**STATE OF TENNESSEE  
DEPARTMENT OF TRANSPORTATION  
DESIGN DIVISION**

**INSTRUCTIONAL BULLETIN NO. 13-08**

**Regarding New and Revised Standard Drawings**

**Effective for the July 12<sup>th</sup> letting (May 1<sup>st</sup> turn-in),** the following Standard Drawings are new or revised and Section V of the Design Guidelines is revised for this update.

MARKING DETAILS  
FOR  
EXPRESSWAYS  
& FREEWAYS

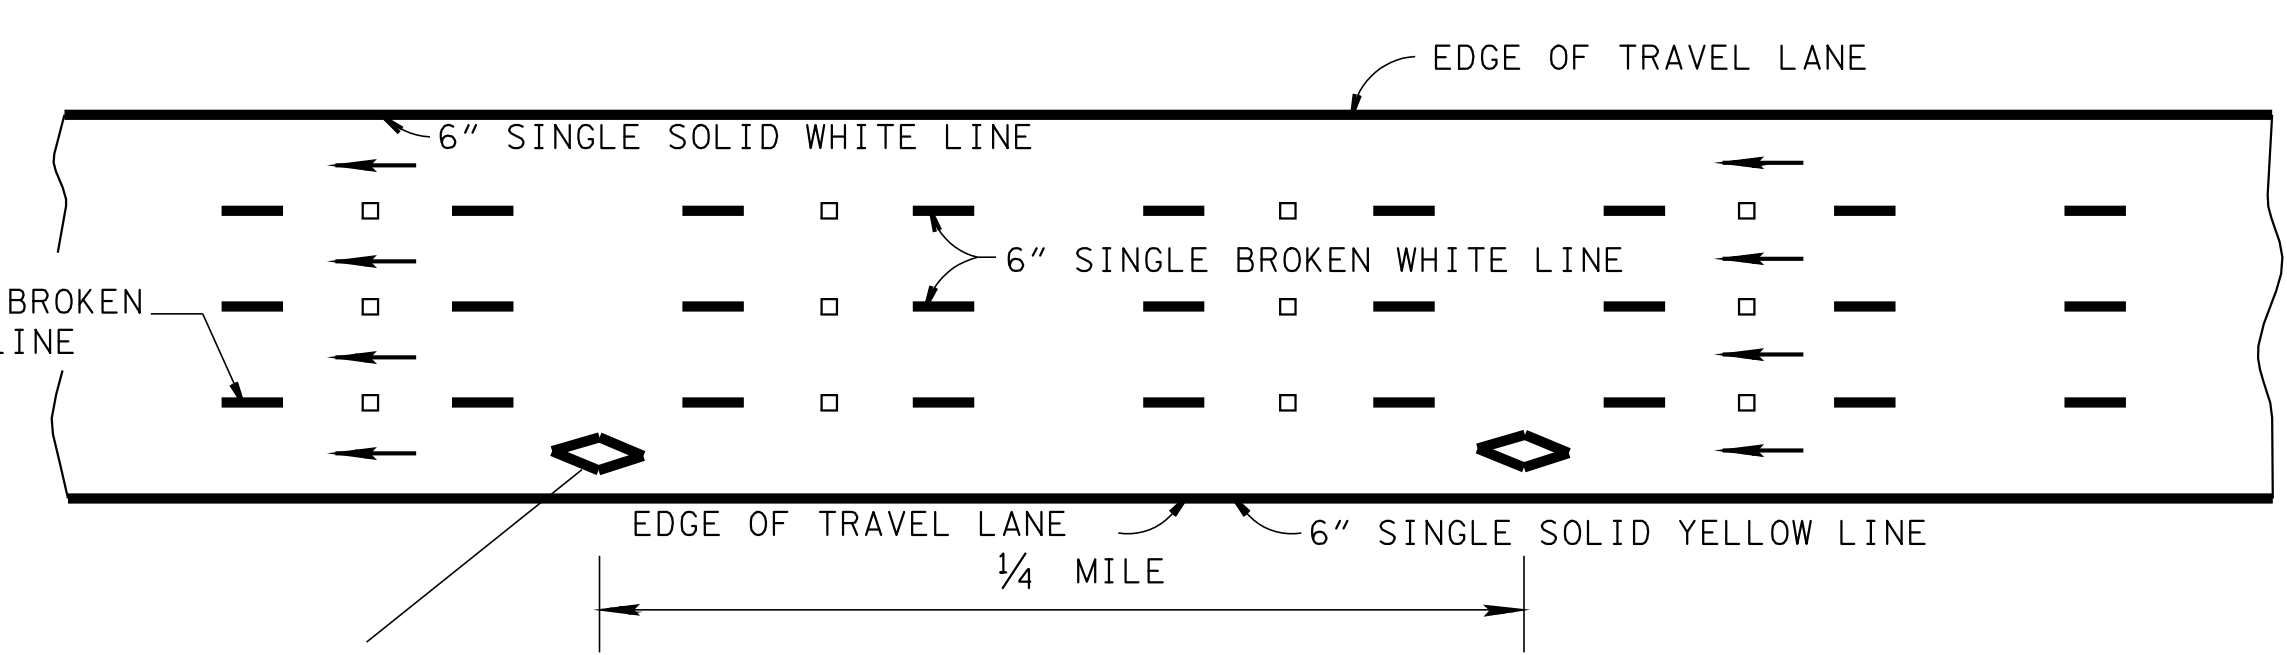
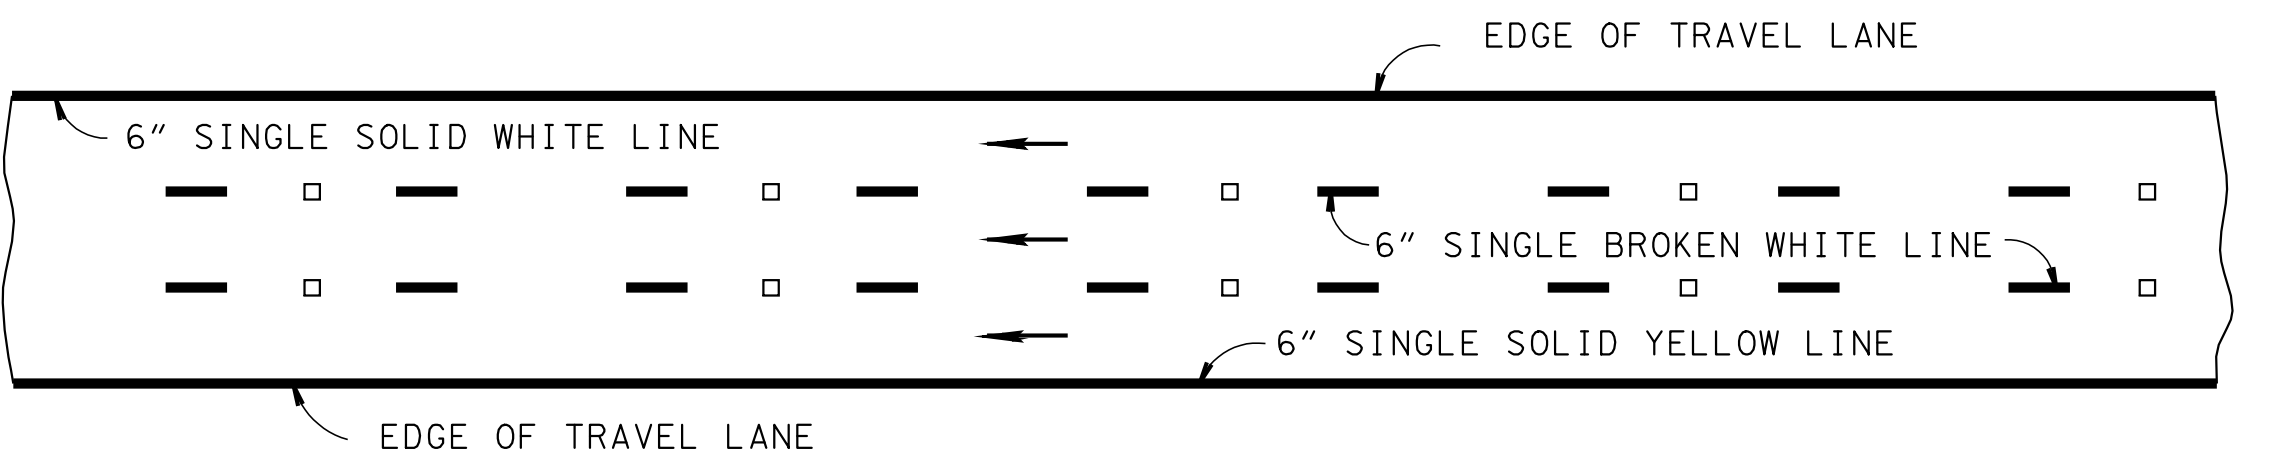
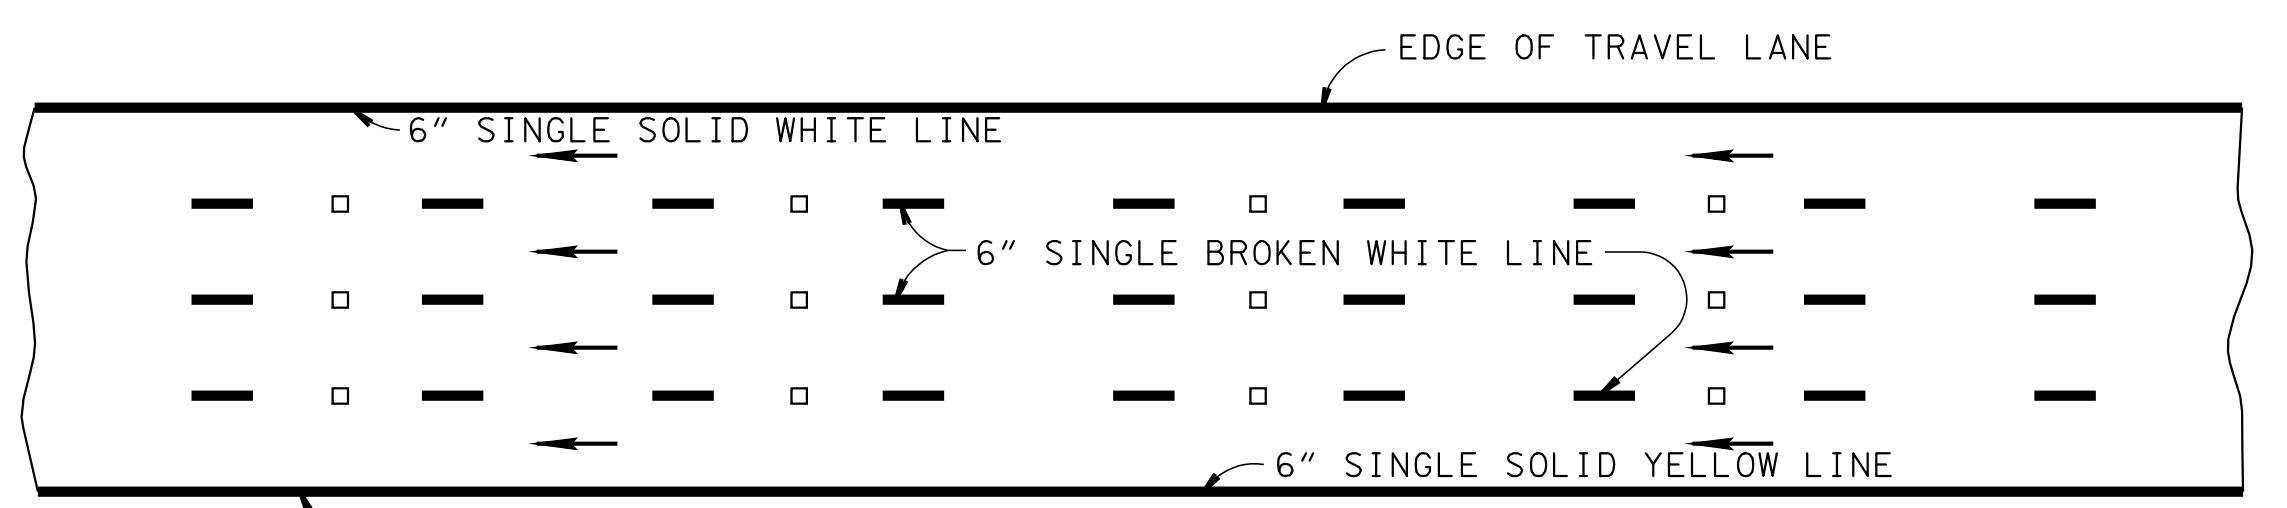
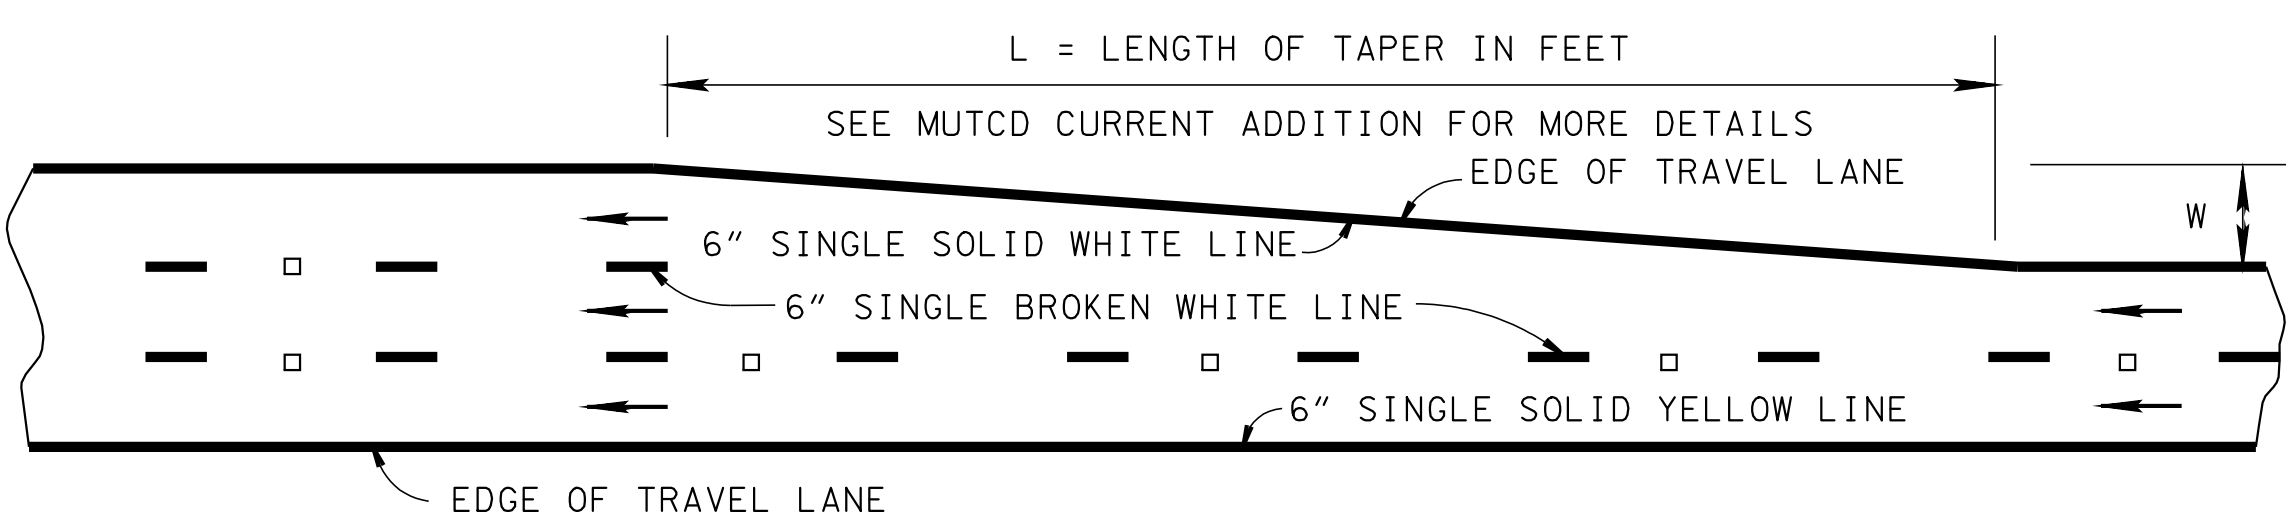
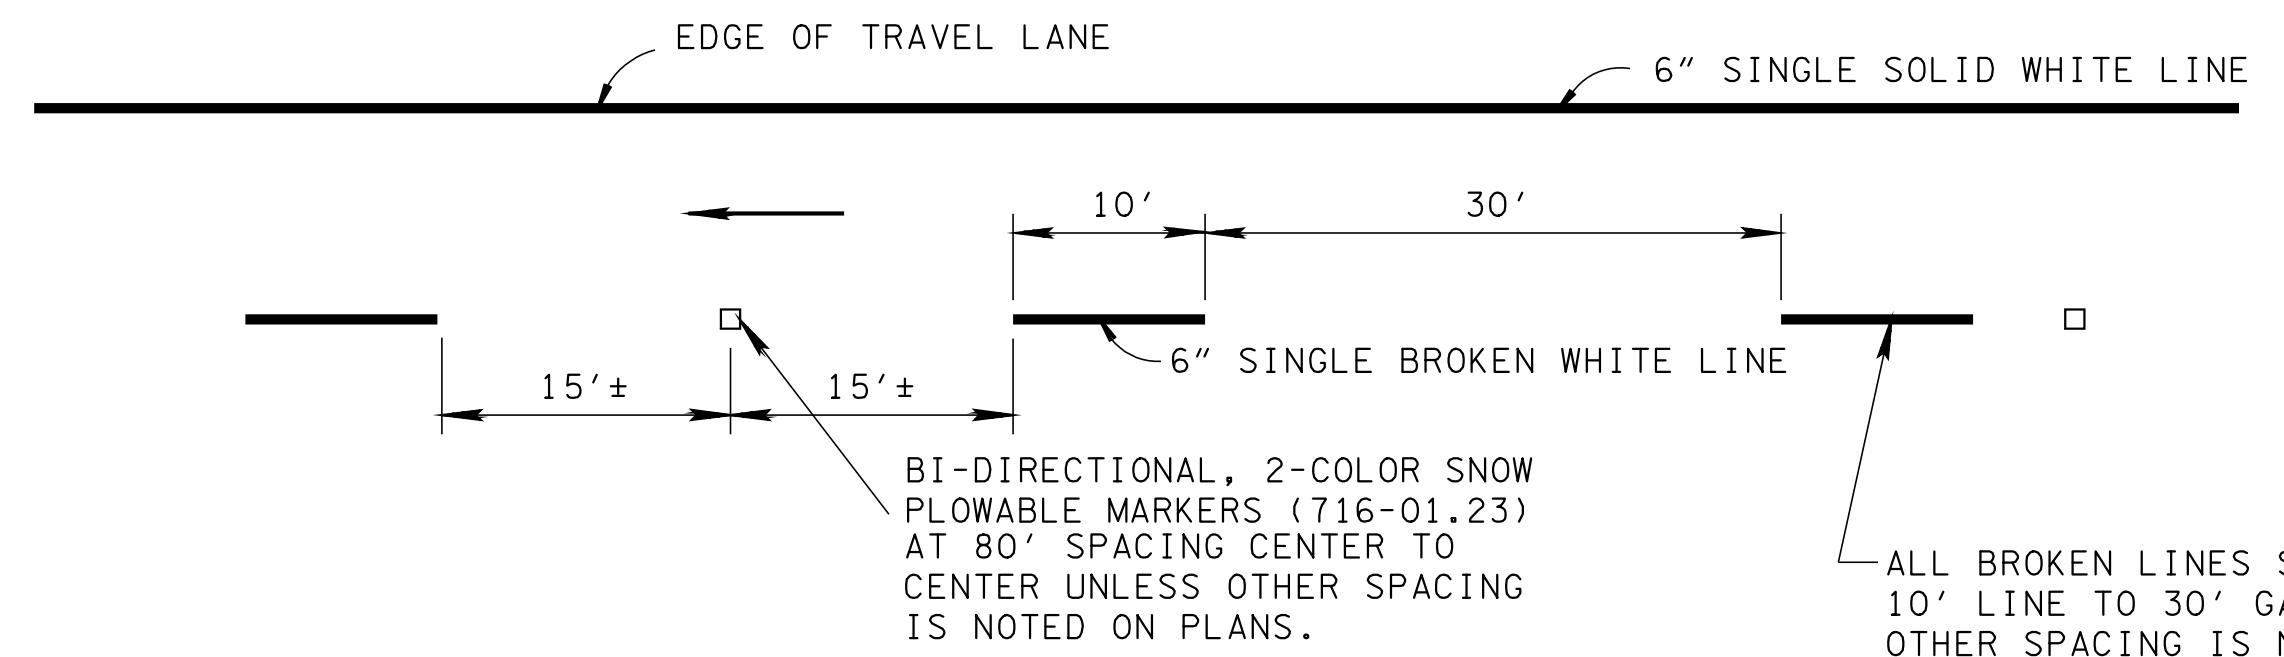
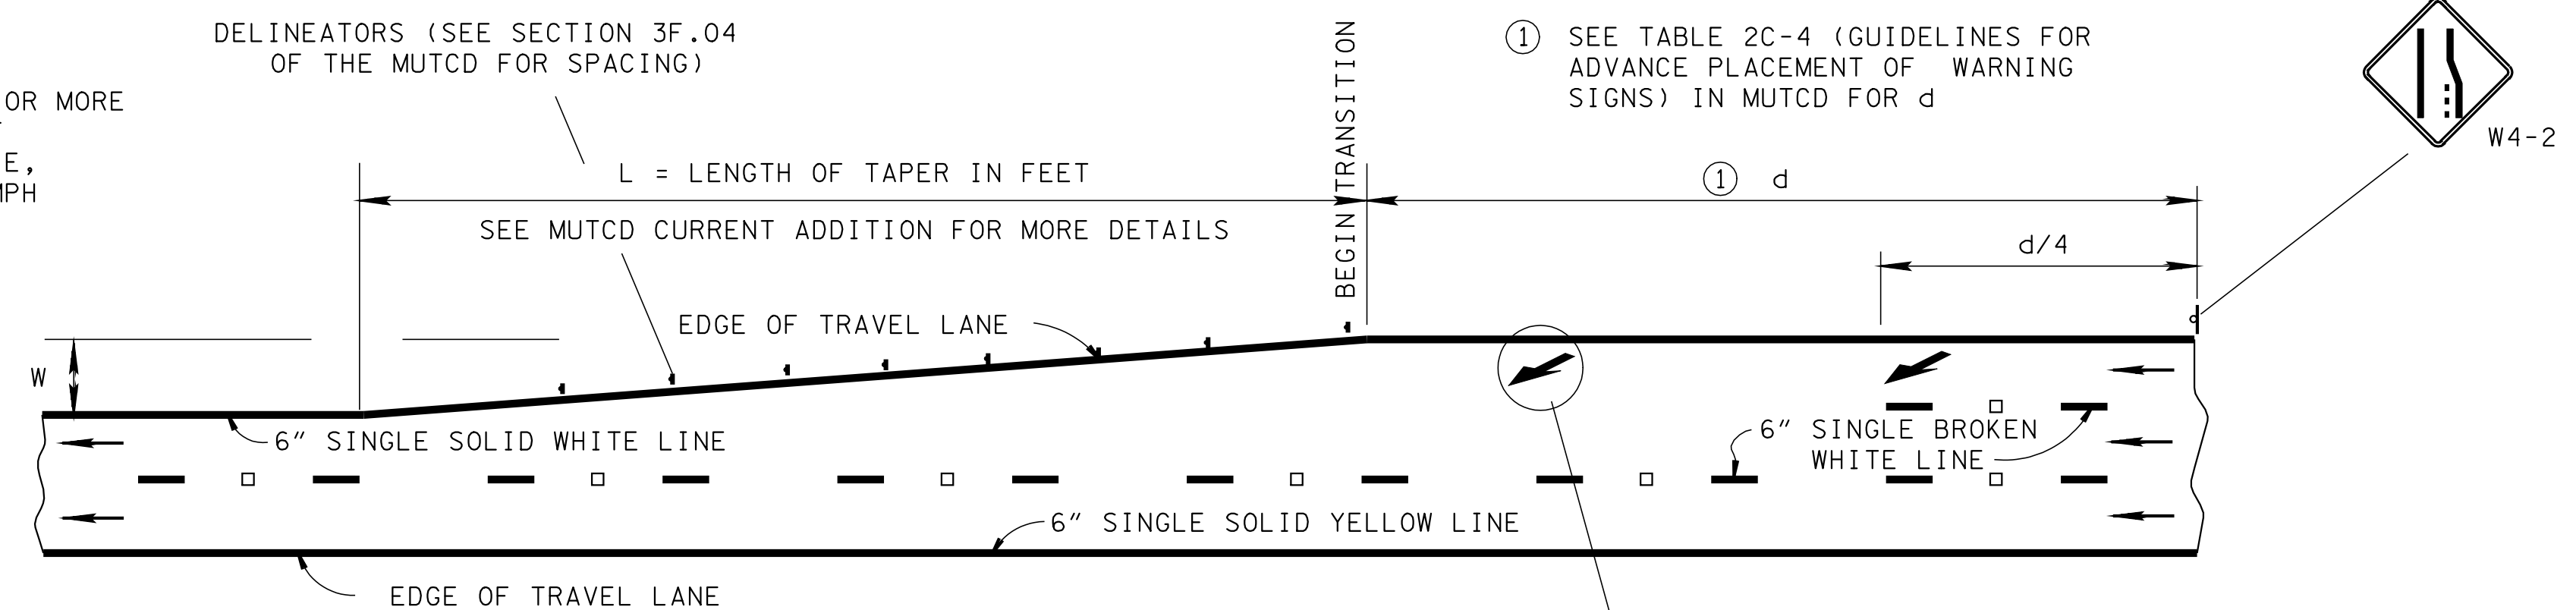
- REV. 9-5-04: IN TYPICAL SHOWING ENDING OF ADDITIONAL LANE CHANGE NOTE ①.
- REV. 11-1-11: ADDED HOV SIGNS AND PAVEMENT MARKING DETAILS. ADDED LANE REDUCTION ARROWS WITH DETAILS, REVISED PAVEMENT MARKINGS TYPICAL DETAILS.

- REV. 1-12-12: CHANGED SNOW PLOWABLE MARKERS FROM MONO-DIRECTIONAL TO BI-DIRECTIONAL 2-COLOR.
- REV. 5-24-12: REMOVED BROKEN LINE FROM TRANSITION AREA ON BEGINNING OF ADDITIONAL LANE.

- REV. 8-16-12: REMOVED HOV SIGNS.
